**Public Bidding No.: 19-041-4**  
**Malolos-Clark Railway Project for Packages CP N-01, CP N-02 & CP N-03; Construction of Civil Structures: Viaducts, Bridges and Five Stations**  
**Bid Clarification Requests**  
**General Bid Bulletin No. 13**

No.	Packages	Volume & Section No.	Page No.	Clause No./ Title	Reference Text	Clarification Request	Final Response
1	CP N-01		Page 15/40	General Bid Bulletin No. 6, Item No. 46		<p>Final Response: Please see revised ITB 38.2</p> <p>In GBB 6, Item No. 46:            "In the "Signed by:" portion; [position in parent/subsidiary company]            The Bidder is proposing to revise the text in accordance to 1TB 38.2 on BDS."</p> <p>Final Response:            "Please see revised 1TB 38.2."</p> <p>The Bidder can't find the revised 1TB 38.2 in GBB6. Please provide.</p>	<i>Refer to Annex A of Bid Addendum No. 5 for revised bidding documents.</i>
2	CP N-01	Vol.1A Sec.4A BOQ	BOQ-24 BOQ-25			<p>In the Bid Bulletin No. 6 issued by the Employer, items and quantities in the new BOQ for the Structural Works of Calumpit Station have changes but there is no revised drawing issued. Please confirm that there is no change in the original drawing, only in the B

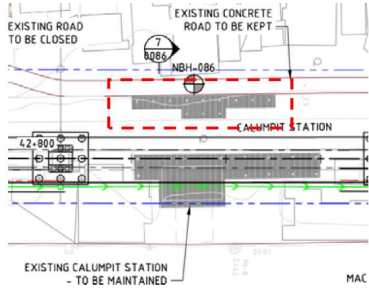
5	CP N-01	Volume 2, Part II, Section 6, Part 1, GS 133		Demolition of Structures and/or Obstruction within Right of Way		<p>The Contractor shall be responsible for demolishing and clearing those structures and/or obstruction, and removing and disposing any materials and/or wreckage arising from such demolition and clearing, and shall, following the survey conducted under GS 133.2.2 above, provide the Engineer with a discrete demolition and clearance programme showing the order in which the demolition work shall be conducted. This programme shall be accompanied by method statement(s) detailing the manner in which the Contractor shall carry out the works.</p> <p>The Bidder's understanding under Part III(A) Scope of Works 2.1.1 (Preparatory Works) is that obtaining of all permits and clearance required by the authorities will be the responsibilities of the Contractor prior to the execution of the demolition works but the application of it only after the survey was conducted under the GS 133.2.2. Please confirm.</p> <p>2. GS 133 does not specified how this item shall be paid. The Bidder would like to know on how this item shall be paid to the Contractor and relevant permits required?</p> <p>3. In addition, who will do the restoration for the structures that are partially demolished within ROW and how it will be paid if it will be the Contractor's Scope?</p> <p>4. The Bidder would like to know the status of the Land Acquisition specially those affecting the foundations of Pier and Stations.</p>	<p><i>1. Please refer to the Provisional Sum for the works under GS 133.2.2. For works under SoW 2.1.1, please refer to Bill No. 1 of the BoQ.</i></p> <p><i>2. See response no. 1.</i></p> <p><i>3. Not the contractor's scope.</i></p> <p><i>4. Refer to "Status of Land Acquisition Drawings" issued under GBB No. 09.</i></p>

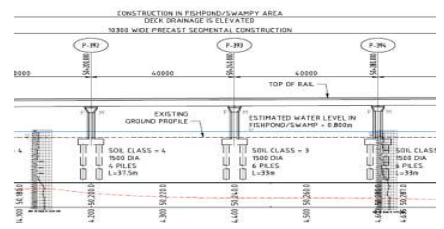
94	CP N-01 CP N-02 CP N-03	Volume 2 Section 6 The Employer's Requirements (ERQ)		MCRP-DWG-VIA00-ST-0320		<p>The PILE NOTES in the drawing (MCRP-DWG-VIA00-ST-0320) of addendum #2 is REV 01. However, it was REV 02 in the drawing of addendum #1.            Please clarify which drawing the Contractor shall follow.</p>	Refer to the latest issued drawings under GBB No. 12.
95	CP N-01 CP N-02 CP N-03	Volume 2 Section 6 The Employer's Requirements (ERQ)		MCRP-DWG-VIA00-ST-1651, BOQ-17		<p>Bored Piles for Emergency Staircases</p> <p>Bored Piles for Emergency Staircase has been changed in size from D1000mm to D800mm as per Addendum 2. However, there are still remaining quantity in the BOQ for D1000mm when only D1000mm piles were for the emergency staircases. Please check if the quantity of D1000mm still remains.</p>	Refer to the latest issued drawings under GBB No. 12.
96	CP N-01 CP N-02 CP N-03	Volume 2 Section 6 The Employer's Requirements (ERQ)		MCRP-DWG-VIA00-ST-1653		<p>Depth of Bored Piles in Emergency Staircases</p> <p>Depth of piles in the emergency staircase were indicated in the drawing MCRP-DWG-VIA-ST-1653 in ADD1. However, the depth of the piles has been deleted in the ADD2. Please kindly clarify the depth of the piles in emergency staircases.</p>	Refer to the latest issued drawings under GBB No. 12.
